INTRODUCTION

For nearly 20 years, the Electric Power Research Institute (EPRI) has been reviewing the U.S. Department of Energy’s development of the proposed geologic repository for disposal of high-level radioactive waste and spent nuclear fuel at Yucca Mountain, Nevada. Independent analyses and data collection conducted by EPRI suggest that there are many issues with respect to the current DOE design and analyses, as presented in the License Application, that may result in unnecessary occupational health hazards to workers in the nuclear industry and other related industries.

The purpose of this report is to identify those issues and provide semi-quantitative estimates of the “unnecessary” occupational health risks that may result from the DOE Yucca Mountain analyses and repository design such that the proposed analyses and designs are not consistent with ALARA principles. While EPRI recognizes there could be additional, “unnecessary” health hazards to the public due to DOE’s analysis and design, public health hazards are not assessed quantitatively in this report. Except on a limited basis, neither will this report quantitatively

Figure 6 - 1
DOE Seismic Hazard Curve Adapted for Post-closure Use [reproduced from Stepp et al. (2001), Figure 1.7-7]

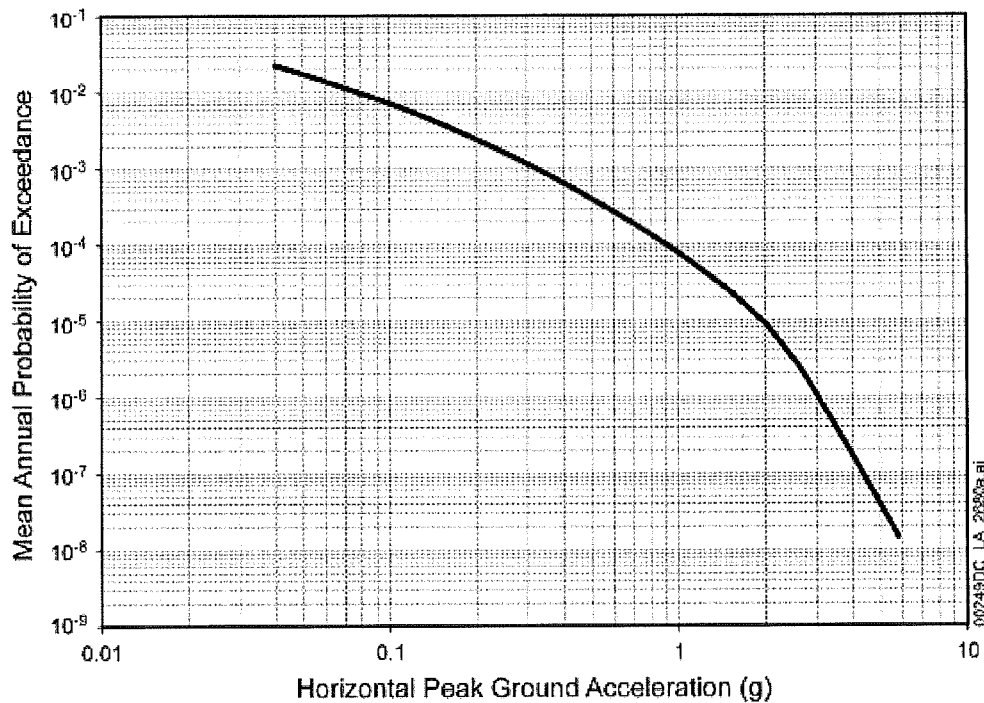
DOE uses ground motions estimated from its Yucca Mountain Probabilistic Seismic Hazard (PSH) model (Stepp et al. 2001). The seismic hazard curve in Stepp et al. (2001) is reproduced here as Figure 6-1. At return periods of 10^6 years, the Yucca Mountain PSH model predicts a mean PGA and PGV of 3g and 400cm/sec, respectively. These are ground motions that exceed the largest magnitudes ever recorded in the world, so there is some uncertainty as to whether they are physically realistic (Bommer et al. 2004). The PGA curve (presented in Figure 1.7-7 of DOE, 2008b) and reproduced here as Figure 6-1, is an extrapolation of the PSHA curve to 10^6 /year and beyond. It is important to recognize that a statistical distribution is just a model of observed data, and extrapolation beyond the range of the data may not be valid. EPRI asserts that the extrapolation of the maximum horizontal acceleration is beyond the region that could be supported by the strength of the rock and soil at Yucca Mountain. In a review of the results of this PSHA, an expert panel convened by the USGS (Hanks, et al., 2006), concluded the following:

While these ground motions can be used to assess the sensitivity of the response of waste emplacement drifts and engineered barrier system components to such high levels of motions, ultimately results should be evaluated for ground motions that are credible for Yucca Mountain.

This statement reflects the fact that even the authors of the ground motion assessment at Yucca Mountain believe that their results are too high and not credible for design. Their use is only recommended for sensitivity studies. Therefore, it is reasonable to conclude that the consensus in the community of earthquake professionals that ground motion estimates at Yucca Mountain are too high at probabilities of 10^{-6} /year and should be lower.

Figure 6 - 2

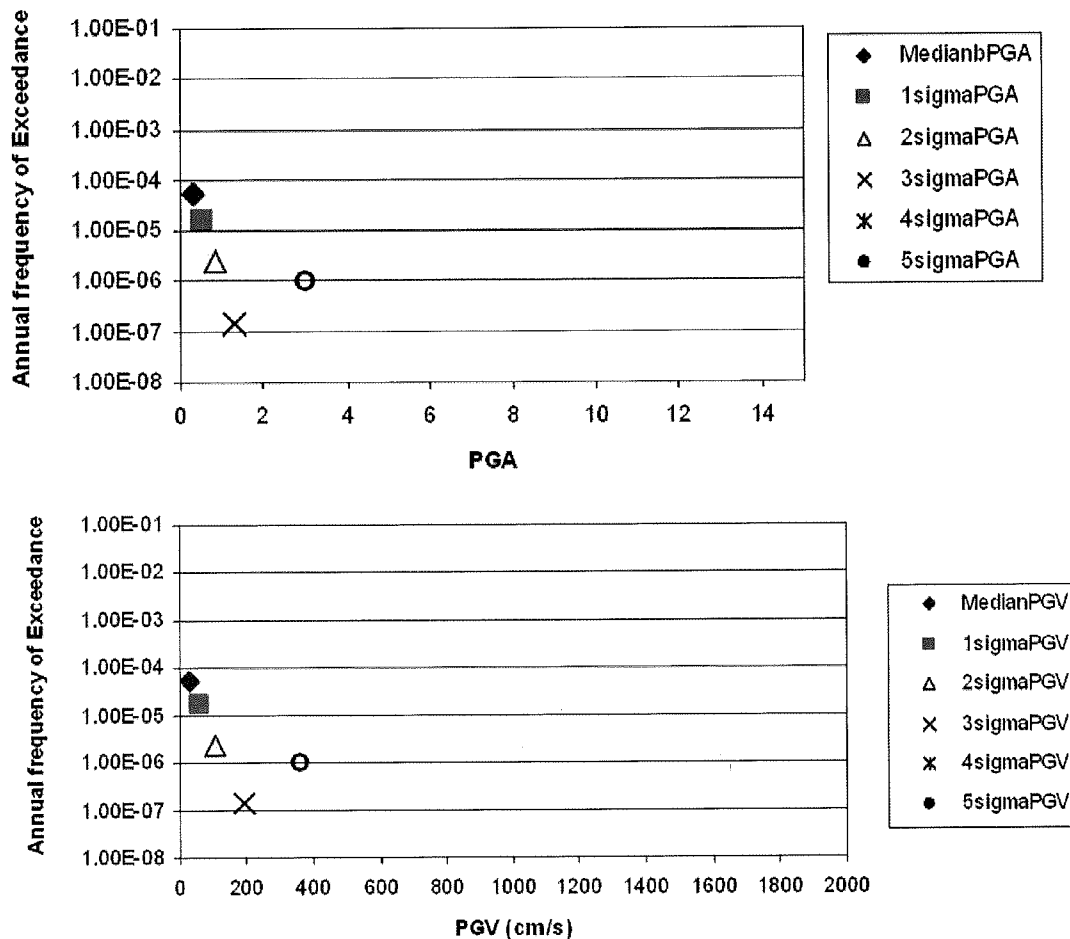
Figure 6-2 shows EPRI's estimates of the annual frequency of exceedance for PGA and PGV for the SCF and a background earthquake. Each horizontal line of three matching symbols on Figure 6-2 reflects the range of magnitudes estimates for the SCF (EPRI 2006b, Table 2-1). The open circles on the graphs represent the mean PGA and PGV for the 10^6 year return period from the Yucca Mountain PSHA (Stepp et al., 2001). The analysis shows the PGA to be about 0.7 to 1g for the SCF at the 10^{-6} /yr annual frequency of exceedance, (10^6 year return period), considerably less than the 3g estimated from the Yucca Mountain PSH model for the same return period. A PGV of 70 to 160 cm/sec is estimated for the SCF at the same annual frequency of exceedance or return period, considerably less than the 400 cm/sec derived from the Yucca Mountain PSHA. Similar results are obtained for the background earthquake (Figure 6-2).

EPRI's hazard estimates for the Solitario Canyon Fault (upper figure) and background earthquake (lower figure) sources. The open circles show for comparison the mean values for the 10^6 /year annual frequency of exceedance (10^6 year return period) from the Yucca Mountain probabilistic seismic hazard model (Stepp et al. 2001).

Figure 6 - 3
Finite Element Model and Analysis Setup for Impact due to Rockfall (taken from Figure 12-1 in EPRI (2005))

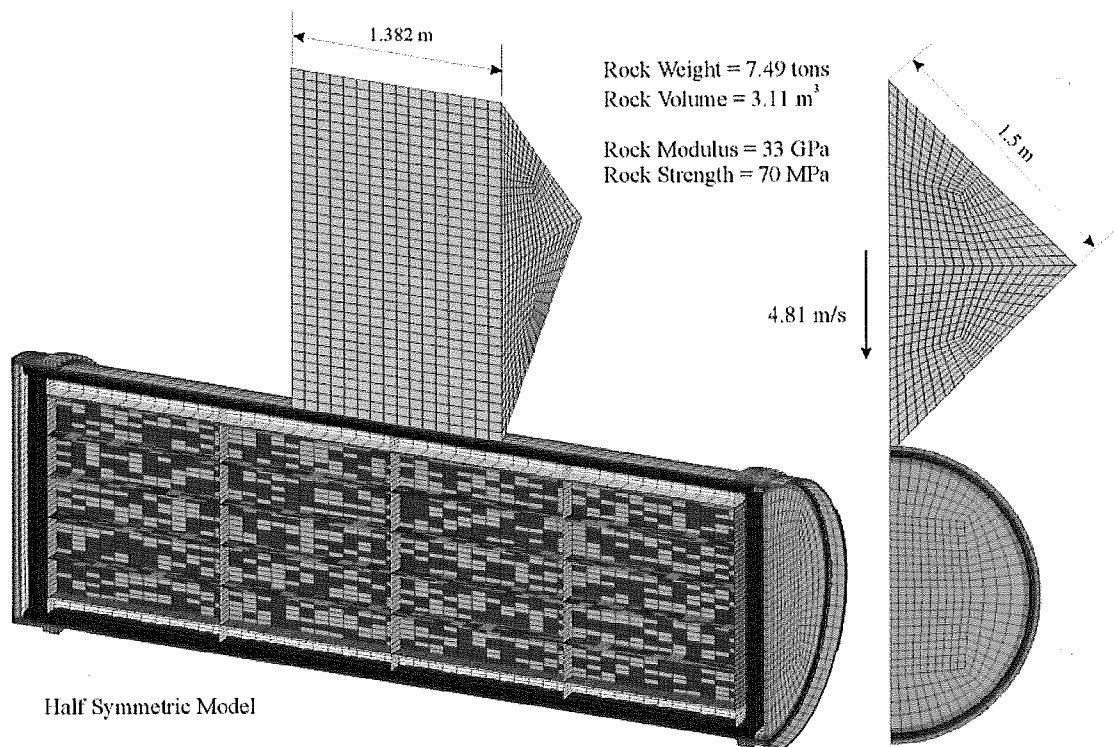
For dynamic loading, EPRI (2005b) conservatively assumed that a large rock block is ejected directly onto the top of a bare WP (i.e., without the DS present), as shown in Figure 6-3. EPRI used an Alloy 22 thickness of 20 mm. The rock block EPRI modeled was assumed to be 7.49 metric tons with a volume of 3.11 m³. This size of rock is the largest size in a representative grouping considered to have a reasonable probability of occurring for the maximum PGV of 2 m/s that EPRI has determined should be associated with a future seismic event near the Yucca Mountain site. This block was assumed to be ejected with a downward velocity of 2 m/s. Furthermore, EPRI (2005b) conservatively assumed that the rock block struck the unprotected WP on a knife edge (see Figure 6-3). EPRI has concluded that even in the event of the

postulated occurrence, the WP internals would not be degraded in a manner such that they would fail to provide sufficient structural support to protect the contents. EPRI (2005b) concludes that:

[A] rockfall impact event with the largest size rock in a representative grouping considered to have a reasonable probability of occurring for the maximum PGV of 2 m/s associated with a future seismic event will have very little effect on the longevity of the Alloy 22 WP outer shell. The response of the Alloy 22 material under the impact will likely remain in the linear regime, even with some corrosive thickness reduction, and thus, residual stresses that could accelerate the degradation from stress corrosion cracking will not be present. It seems especially evident that if residual stresses near the yield strength of the material are needed for stress corrosion cracking, then such a rockfall event will most certainly not affect the performance or longevity of the waste package.

Hence, it is EPRI's position that dynamic rockfall directly onto a WP – without the presence of a DS – will not cause any additional damage compared to the case for which a DS was present. Thus, drips shields are not needed to protect a WP from dynamic rockfall.

Figure 6 - 4
Derived Cumulative Failure Curves for Zircaloy Cladding (EPRI, 2000)

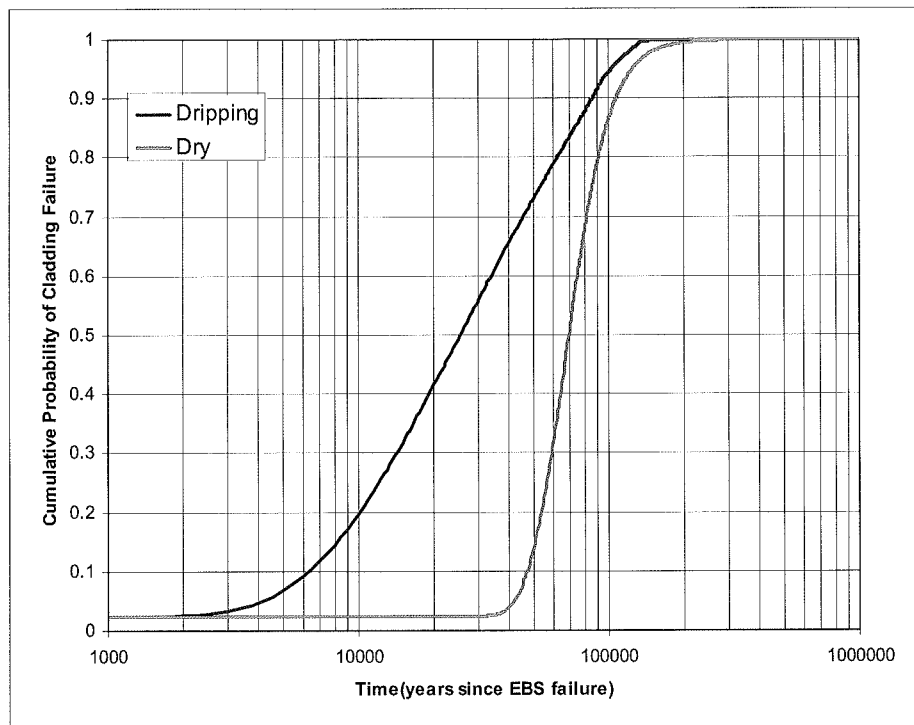
DOE has conservatively assumed that the CSNF cladding will not provide any sort of barrier to the delay or release rate of radionuclides from the UO₂ waste form [DOE 2008b, Section 2.4.2.3.2.3.2.3]. Neither has DOE taken credit for the performance of the inner stainless steel canisters within the waste packages or the outer stainless steel shell of the TAD. Without taking any credit for the performance of cladding or the inner stainless steel barriers, the performance of drip shields would seem to be more important than it really is.

EPRI does find that there is sufficient basis for taking credit for the performance of the CSNF cladding in its TSPA model (EPRI, 2000). Available data on the corrosion of zircaloy CSNF cladding were evaluated to derive an estimated cumulative failure curve as a function of time (Figure 6-4). It was assumed that approximately 2% of the cladding was failed prior to emplacement in a repository. After eventual failure of the waste package/EBS, two corrosion modes for the cladding were considered: (1) general corrosion under dry (moist air) conditions, and (2) general corrosion under dripping conditions. At 10,000 years after EBS failure, about 20% of cladding was projected to have failed under dripping conditions and no additional cladding failures were predicted to occur under dry conditions (EPRI, 2000).

Figure 6 - 5
Comparison of EPRI's Base Case (a) and No Drip Shield (b) TSPA Results

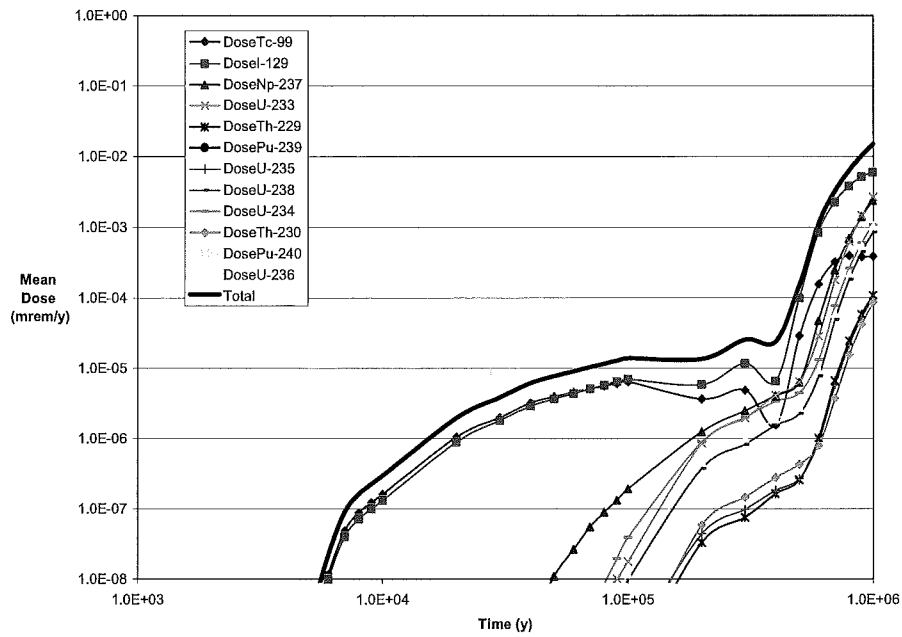
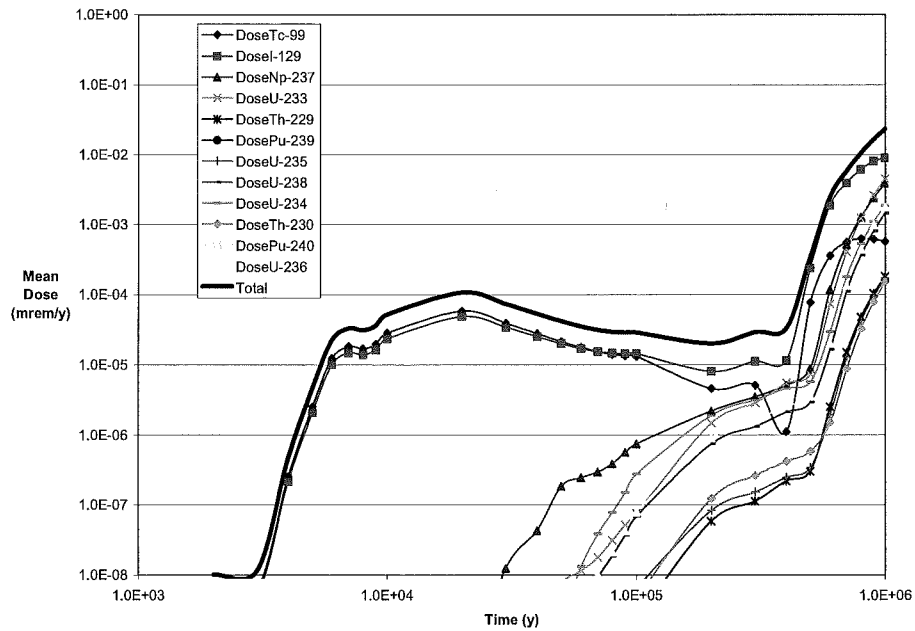
EPRI disagrees that the drip shields are a necessary component of the EBS. EPRI analyses assuming no drip shields, shown in Figure 6-4b, indicate that the dose rates to the RMEI out to 1,000,000 years after repository closure is still significantly less than the proposed EPA dose limits.

EPRI performed a TSPA analysis using its IMARC code to compare EPRI's Base Case (drip shields present) and a sensitivity study for which EPRI assumed the drip shields were not present. Figure 6-5 shows the IMARC results for the Base Case (Figure 6-5a) and that for no drip shields (Figure 6-5b). There is a moderate increase in doses at early times associated with the waste package that is assumed to be initially failed owing to manufacturing defects. It is noteworthy that even in the EPRI analyses, the assumption of one initially failed waste package is a conservatism as the expected value of waste package failures from manufacturing defects is

significantly below one. The change in peak dose without the presence of the drip shields is negligible, and is still well below the limits established in the proposed EPA/NRC standards.
